Addendum Integrated Water Management Plan

Document Number: SMWSTEDS-SMD-PTA-SN600-WA-RPT-044003

This addendum report addresses concerns around drainage on-site detention system and water quality modelling raised in advice from the City of Parramatta Council (CoPC).

Figure 2 Public Domain Grading

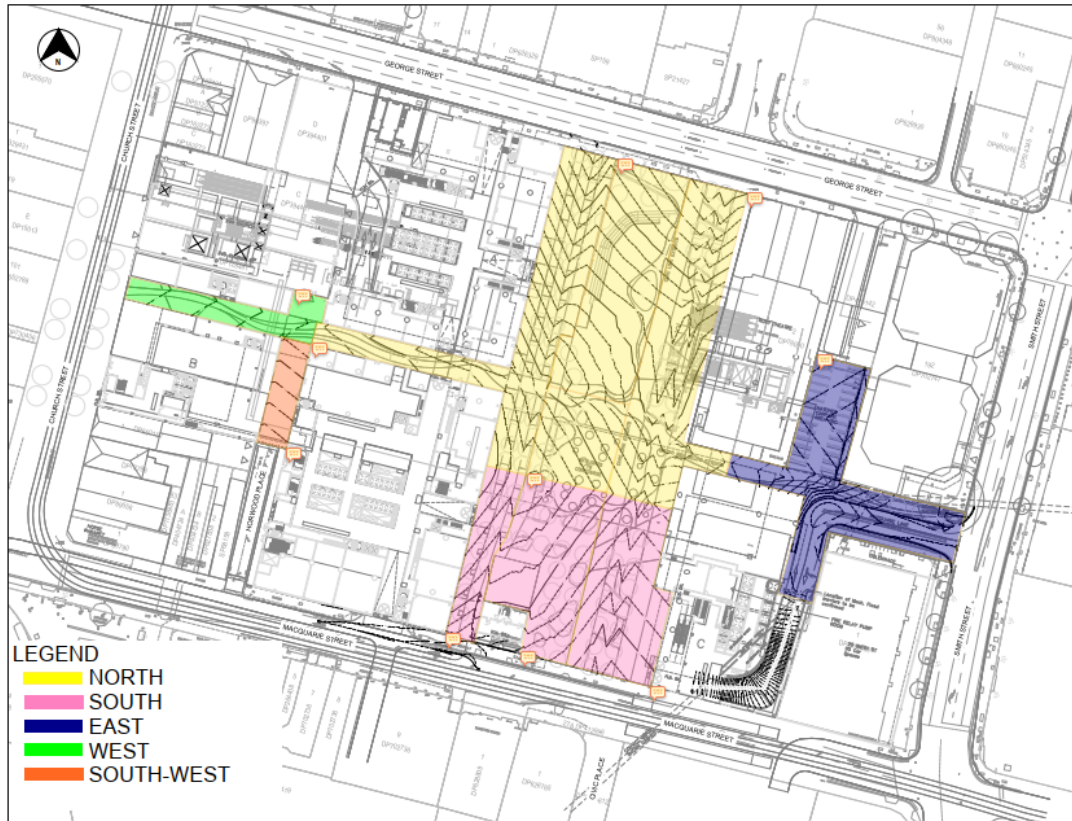
CoPC commented that the proposed drainage arrangement must be updated to include surface grading (surface levels with suitable contour spacing) to provide a clearer view of on the direction of flows. The existing capacity of Council's drainage system must be assessed, it must be ensured there is no increased flows connecting to the system and there is adequate capacity. Detailed drainage plans to be submitted for CoPC review, the diameter of any pipe and longitudinal grades must be shown on the submitted plans. The minimum permissible gradients are shown in City of Parramatta Design Guidelines (2018). The long section of pipes should also be shown on the drainage plans.

Surface gradings and contours have been provided on drainage arrangement plans to show the direction of flow. The existing capacity of the drainage systems has been assessed, with the results showing decreased post development flows in all directions even with the inclusion of climate change factor. Pipe diameter and longitudinal grades have been included within the drainage package and are designed in accordance with CoPC Design Guidelines.

Figure 10 MUSIC Model for Parramatta metro station

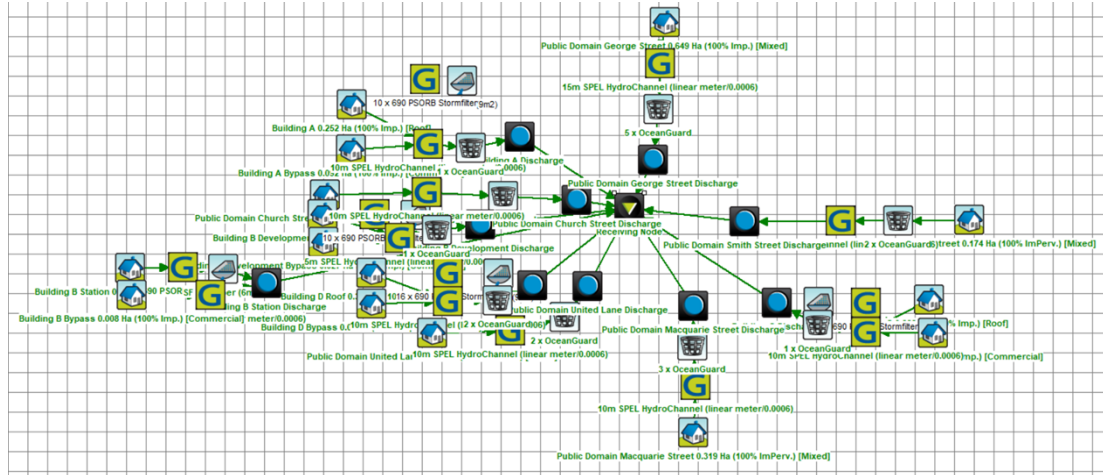
CoPC commented that an electronic copy of MUSIC Model must be provided to Council for assessment and review. Council recommends using PARRAMATTA NORTH MASONS DR (66124) RAINFALL STATION 6 minutes data from 1988 to 1998 (10 years). It is also available in MUSIC-Link for MUSIC_X.

The MUSIC model has been updated with Parramatta North rainfall data as requested.
